ADDENDUM NO. 2

June 5, 2023

LAKE STREET ELEMENTARY SCHOOL ADDITIONS, RENOVATIONS, AND RELATED WORK

Addendum Two (AD.02) to the drawings and specifications prepared by Gibraltar Design for **Lake Street Elementary School Improvements** for Crown Point Community School Corporation, Crown Point, Indiana.

© GIBRALTAR DESIGN	SHEET
D	T-104

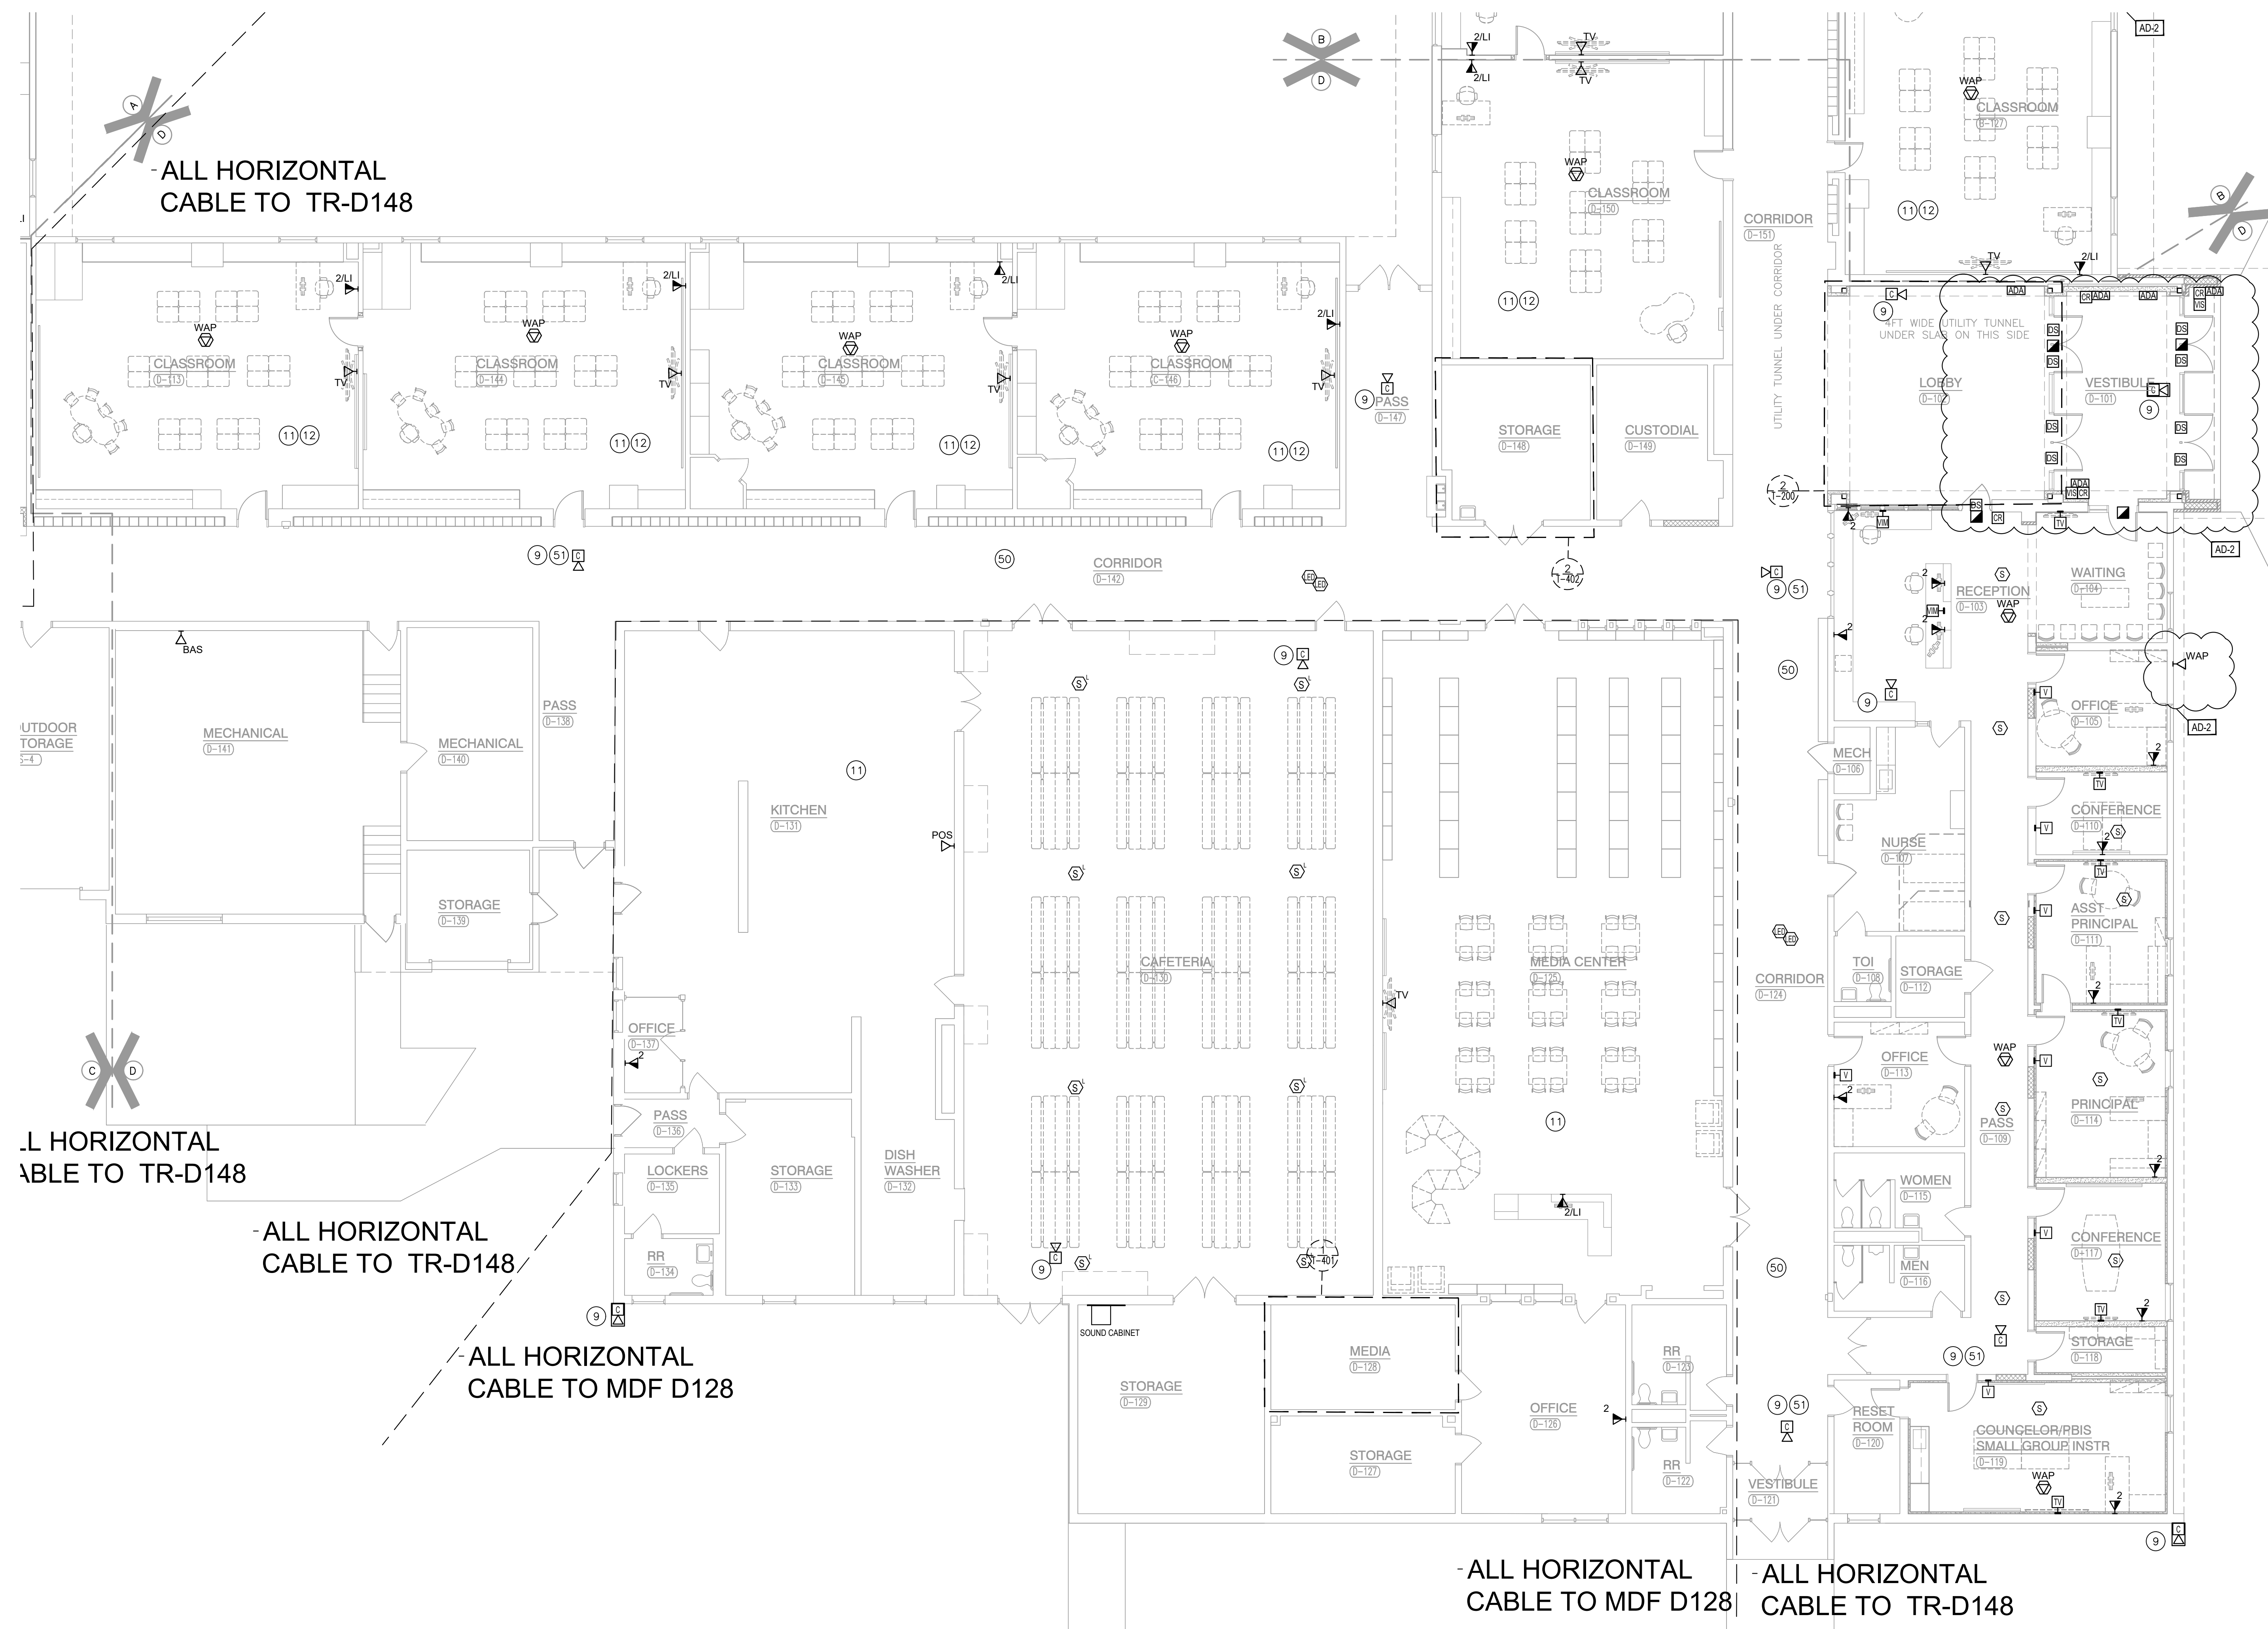
25. Sheet T-104

- A. Refer to revised, full-size drawing, included in this Addendum, for the following revisions:
 1. Office D-105 exterior, added new WAP location.
 2. Vestibule D-101 and Lobby D-102, reconfigured door access control requirements

© GIBRALTAR DESIGN	SHEET
B	TD-102

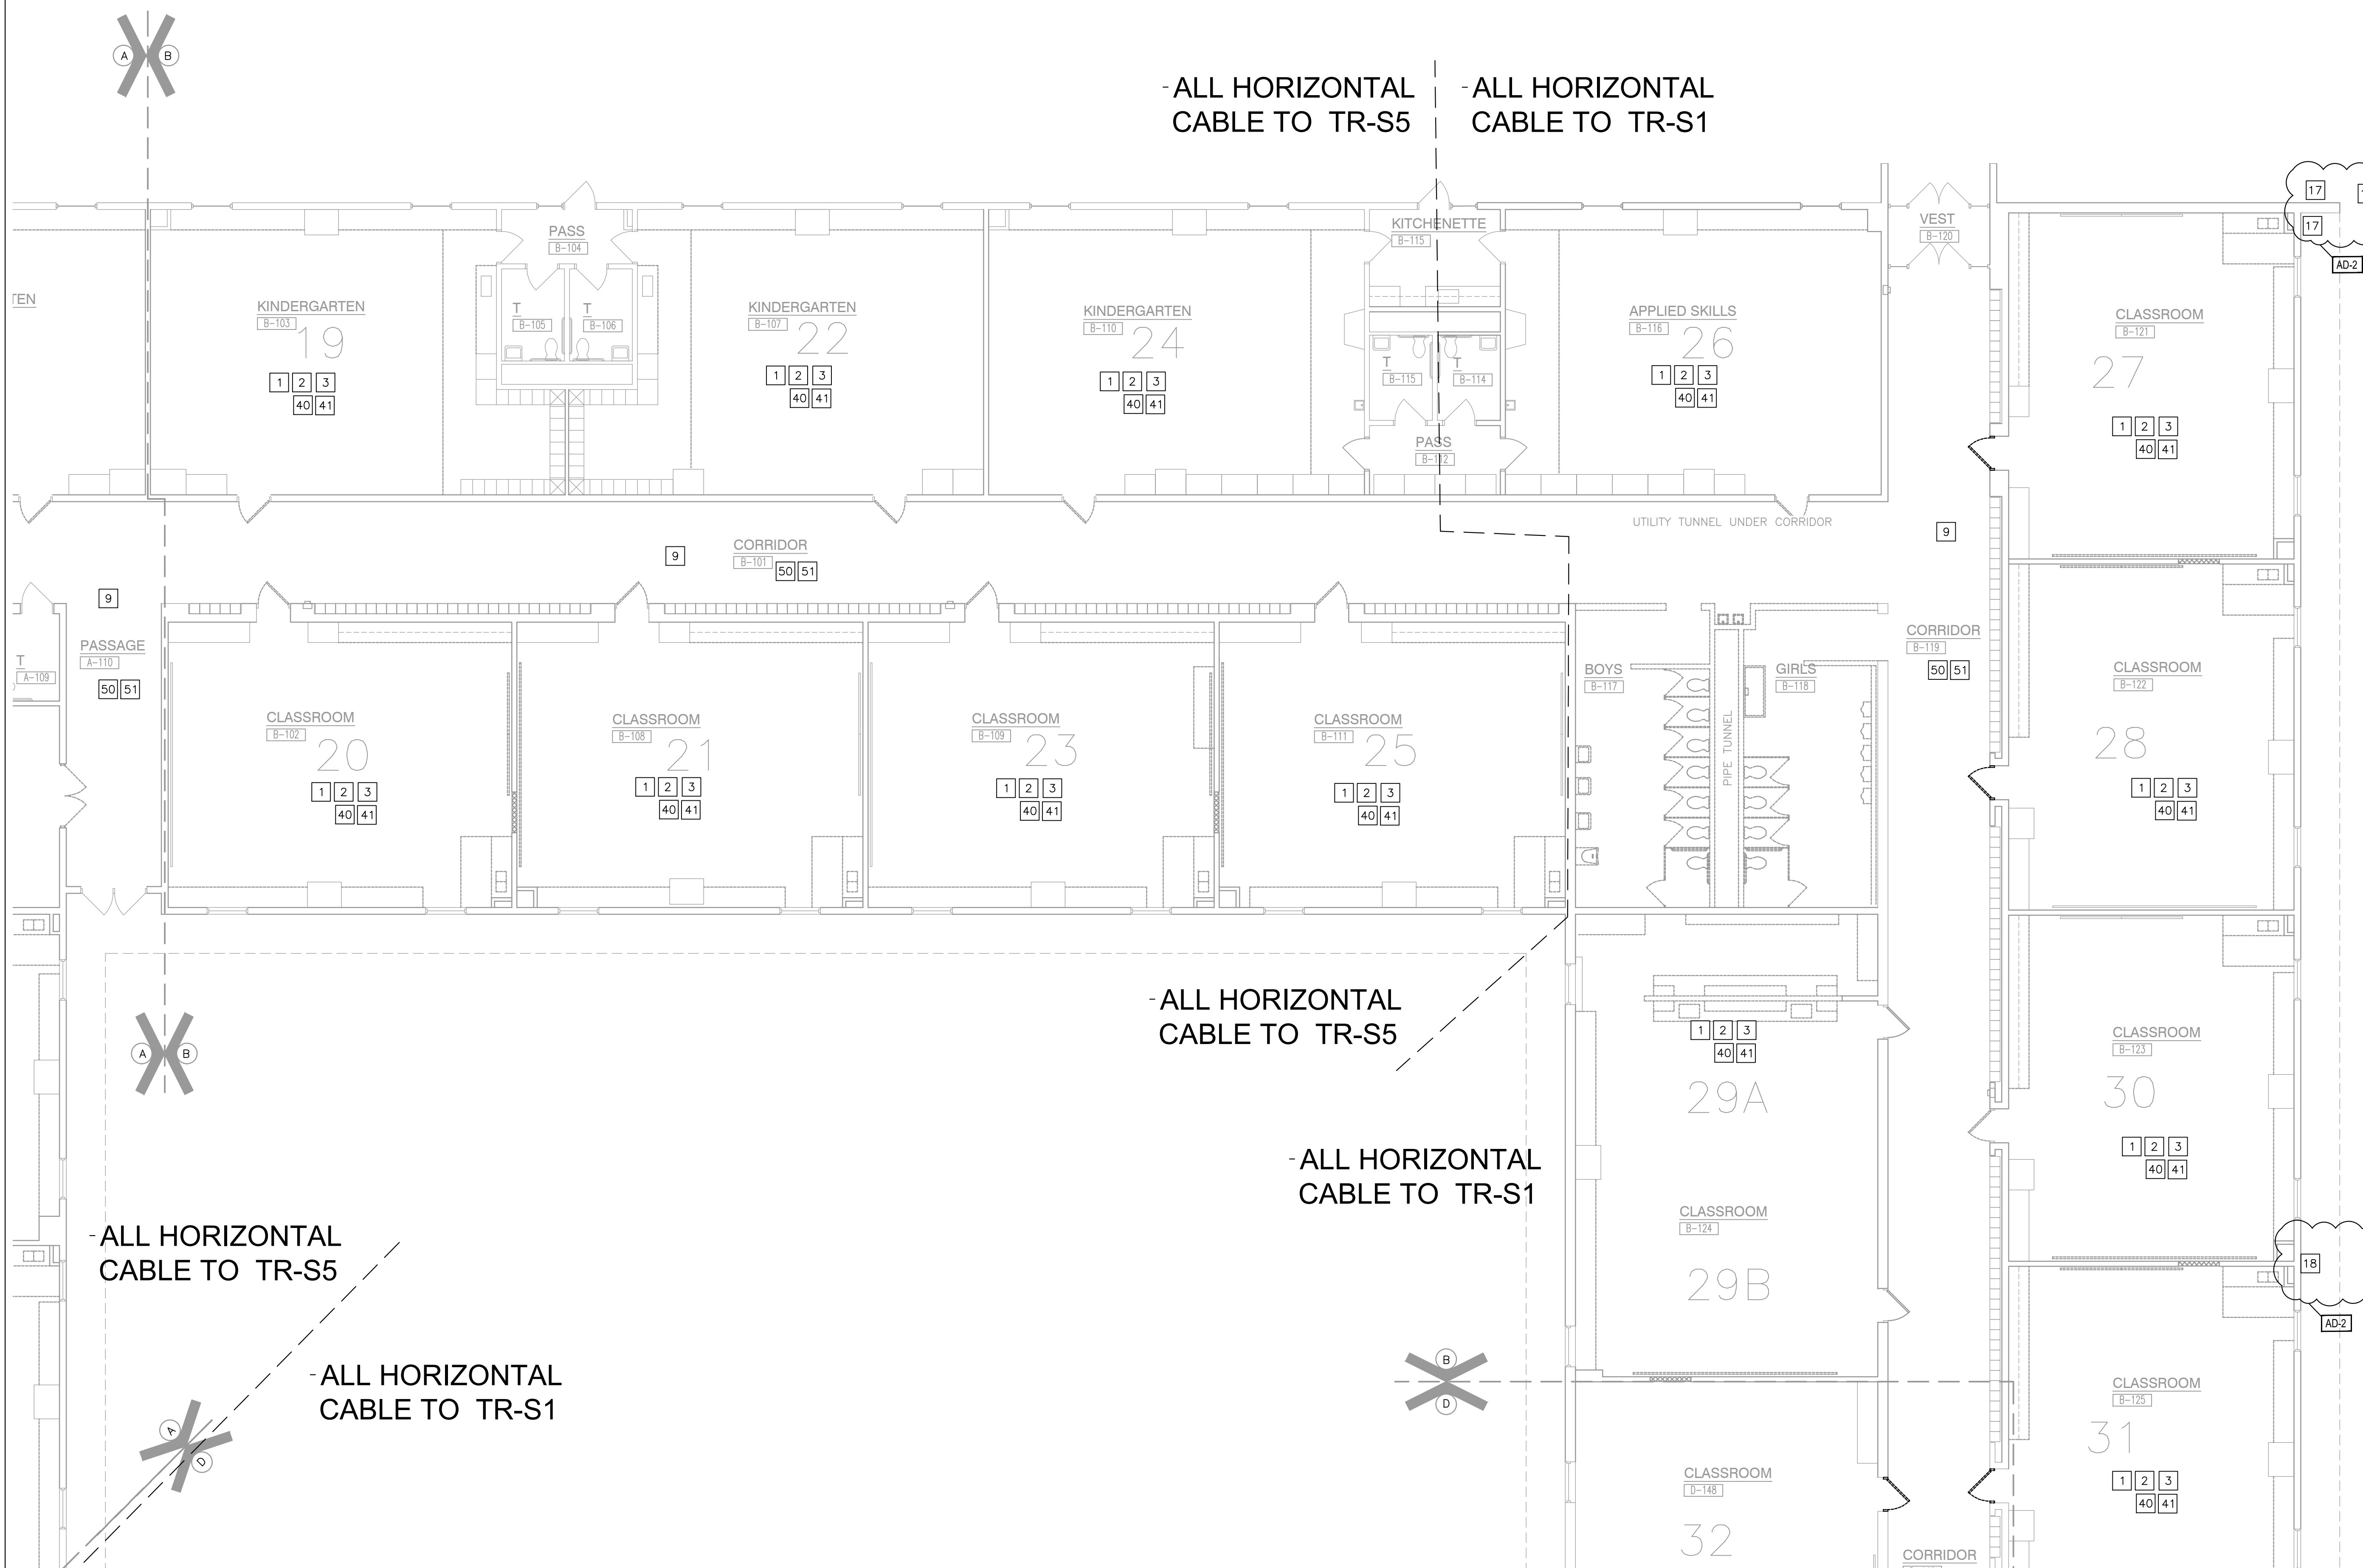
12. Sheet TD-100 through TD-104

- A. Refer to revised, full-size drawing, included in this Addendum, for the following revisions:
 - 1. Revised Demo Notes
 - 2. Added demo note locations on the plans.
